**Re: Variance Request (17-8-201)**  
**Round Bay – Lots 35 & 36**  
126 Round Bay Road  
Severna Park, Maryland 21146  
Tax# 03-697-23242800

VARIANCE PLAN DEVELOPED CONDITIONS SITE PLAN ROUND BAY ~ LOTS 35 & 36 126 ROUND BAY ROAD SEVERNA PARK, MARYLAND 21146 TAX ACCT. NO. 03-697-23242800 TAX MAP 0032 GRID 0014 PARCEL 0184 DISTRICT 3RD ANNE ARUNDEL COUNTY, MARYLAND			
SCALE: 1"=20'	DATE: 7/7/2025	PROJ. NO: RT01725	SHEET 2 OF 2

### CONFIRMATION OF PRE-FILE (2025-0055-P)

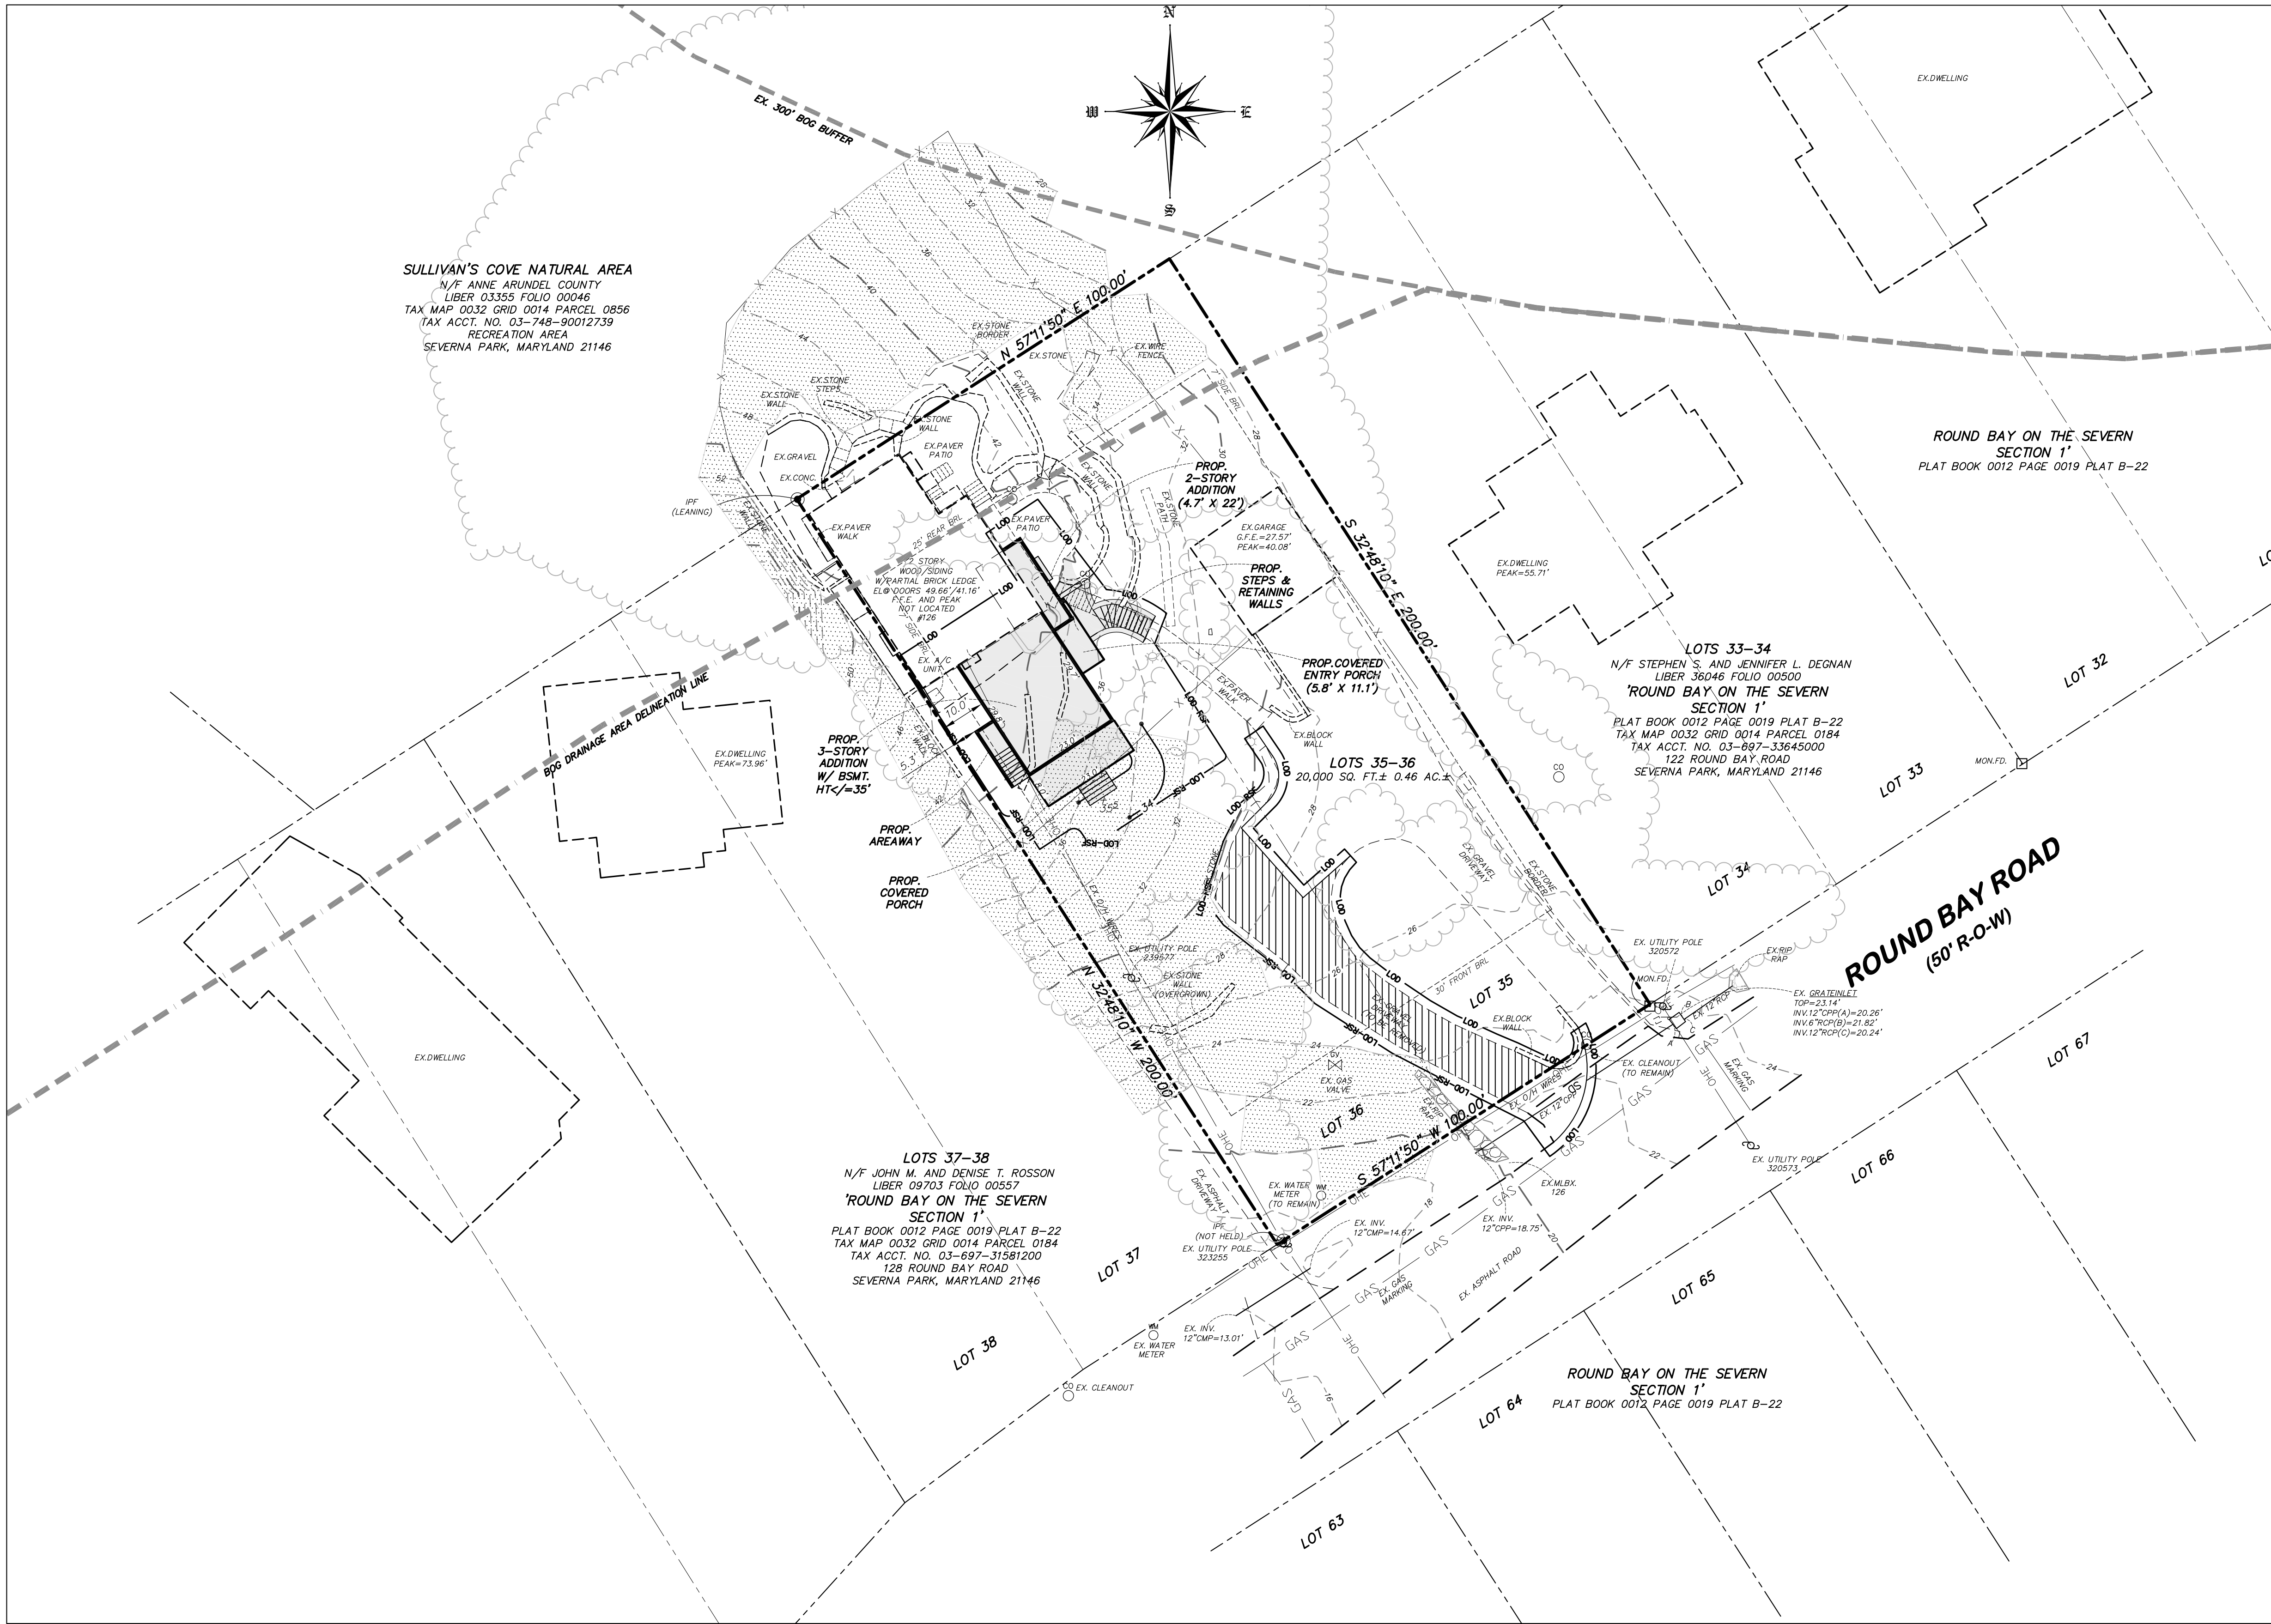
The **Critical Area Team** reviewed the proposal and has no objection to the expansion of the existing dwelling; however, the applicant must demonstrate that the proposal meets the approval standards for a Critical Area Variance, specifically why the footprint could not be designed or located to avoid disturbance to the slopes.

The **Zoning Administration Section** notes that the proposed areaway and stairs must be located at least five feet from the side property line. Please label the distance between the areaway/steps to the side property line to ensure that the setback complies with 18-2-301(b). The applicant is advised that, in order for the proposed Critical Area variance to be approved, the applicant must demonstrate and the Hearing Officer must find that the proposal complies with each and every one of the Critical Area variance standards provided under Section 18-16-305(b) and (c).

1. Show and label the stormwater management devices.
2. Identify if the existing water and sewer are to remain. If not, show the new locations.
3. There are existing improvements on the County-owned property, Sullivan's Cove Natural Area. What is to be done with them?
4. Label the property to the northwest as Sullivan's Cove Natural Area.

5. A portion of the property is located within the Sullivan's Cove Bog contributing drainage area. Show and label the limits of the contributing drainage area on the plan. Show and label the nearby 300-foot bog buffer too.

The Zoning Administration commented that the areaway is to be dimensioned to show in compliance with zoning setbacks. The plan now shows the areaway/steps are located 5.5 feet from the side property line, only extending 3-ft into the setback which complies with 18-3-201(b).

The Engineering division inquired about the existing improvements on the adjacent Count-owner property to the north and what the intention are for them. These existing walks, steps, and walls retain soil and removal of the walls and improvements may create an adverse erosive property condition. The requested variances to the Code are not associated with the improvements.
